July 2018

Important Product Safety Bulletin
Eaton Heavy Duty 30A and 60A Safety Switches

Figure 1. Location of catalog number and date code.

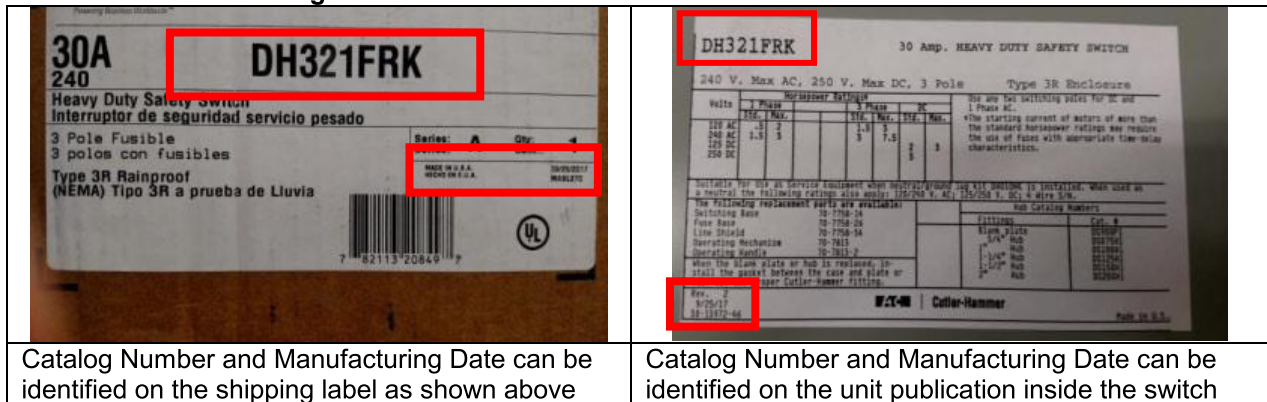
This issue affects various configurations of **30A and 60A Heavy Duty** safety switches **manufactured between November 19, 2015 and January 23, 2018**. Please see Appendix B for a complete list of affected catalog number prefixes. Potentially affected switches can be identified using the information identified in Figures 1 and 2.

Identify potentially affected units using the shipping label or publication shown above in Figures 1 and 2 above. If a yellow dot is located as shown in Figure 2 above, no further action is necessary for that unit.
